REMARKS/ARGUMENTS

[2] Remarks for Amendment to Drawings 4-7:

Amendment to the Drawings:

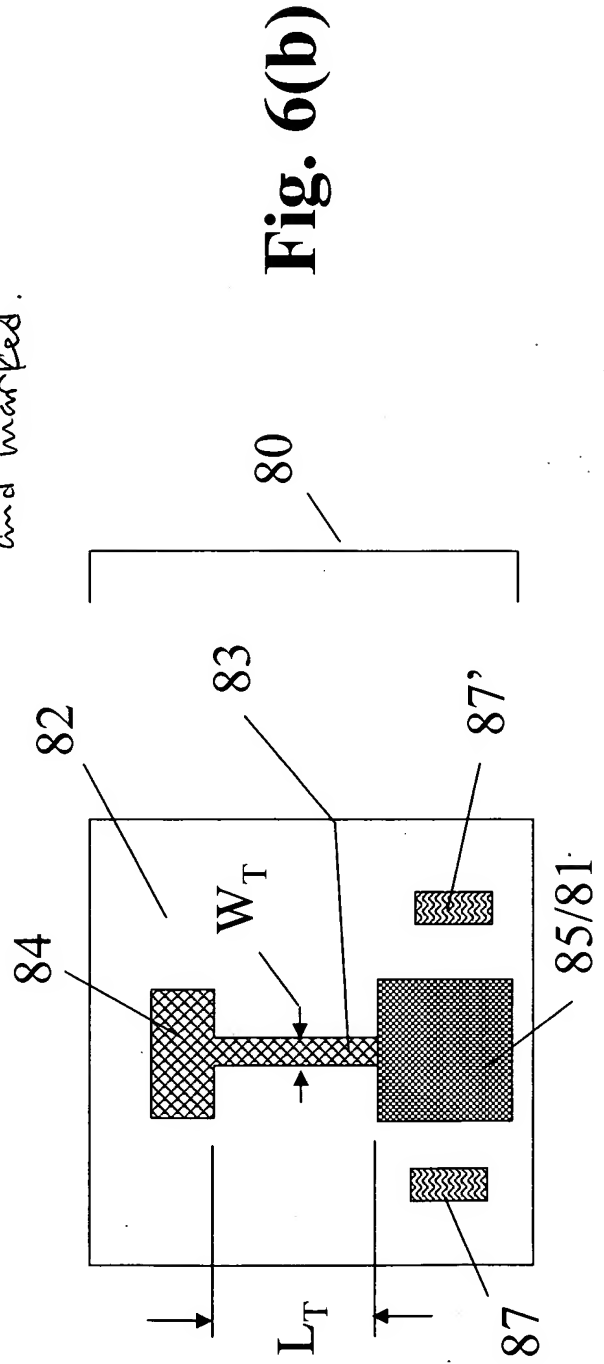
In amended Figs. 4, 5 and 7(b), the previously omitted element number (54) has been added and marked.

The attached three sheets of drawings include changes to Fig. 4-7. The first sheet, which includes Fig. 4-5, replaces the original sheet including Fig. 4-5. The second sheet, which includes Fig. 6(a) and 6(b), replaces the original sheet including Fig. 6(a) and 6(b). The third sheet, which includes Fig. 7(a) and 7(b), replaces the original sheet including Fig. 7(a) and 7(b). In Figures 4, 5, 6(a) and 7(b), previously omitted ground plane (element 54) has been added.

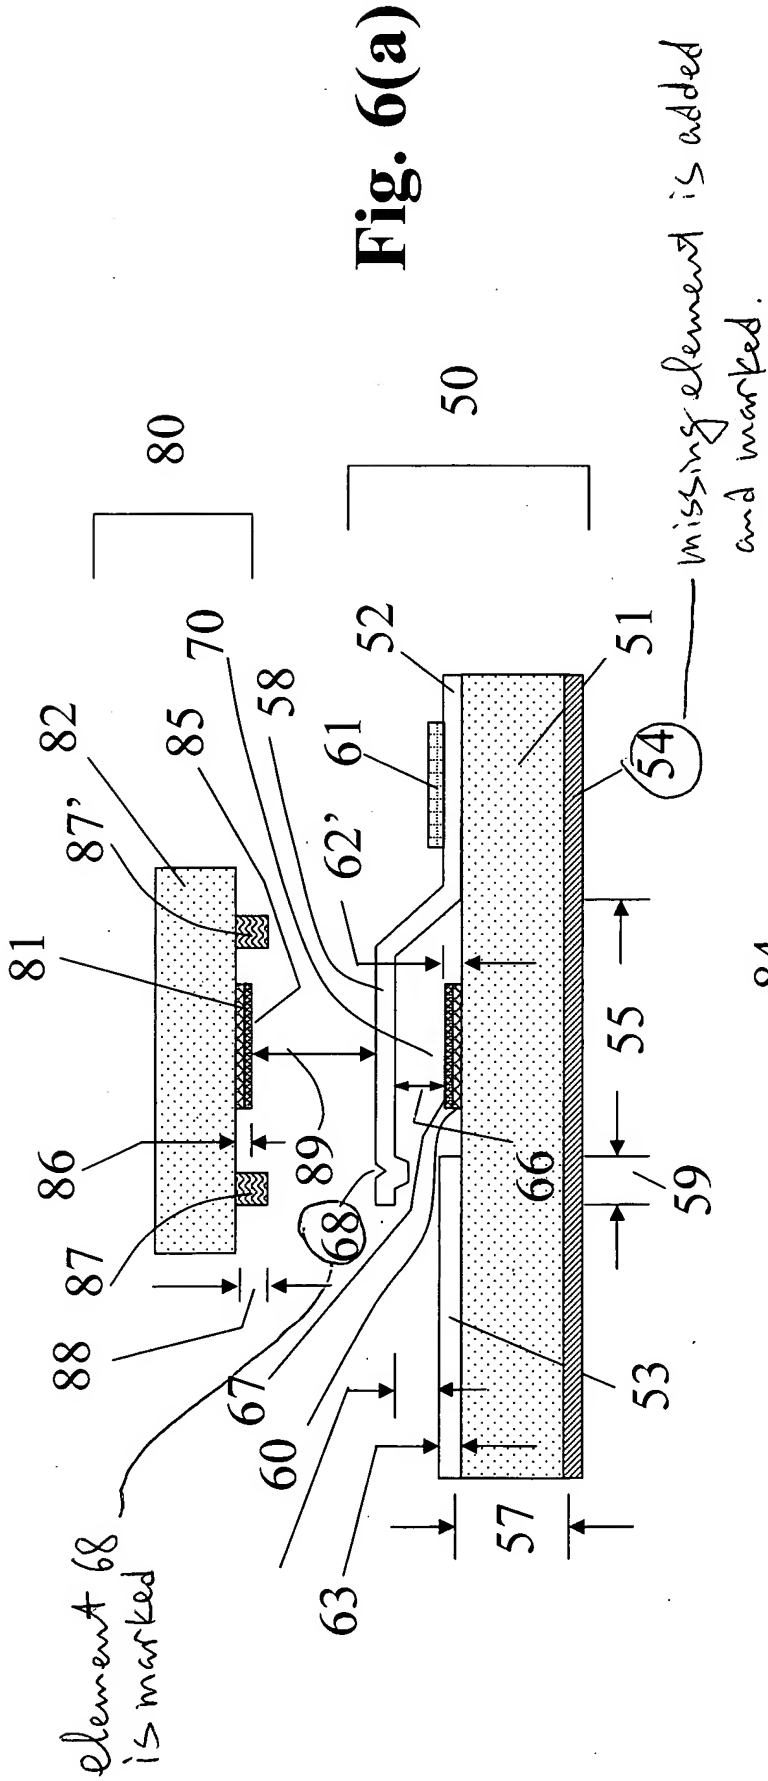
In amended Fig. 6(a), the previously omitted element number (54) has been added and marked and the element (68) has been marked.

After the amendments to Fig. 6(a), a conducting film (54) as the ground plane of the switch (50) is no longer missing.

In Fig. 6(a), the previous missing label for recess region (68) is added and a description sentence for all elements depicted in element (50) including (68) is added.
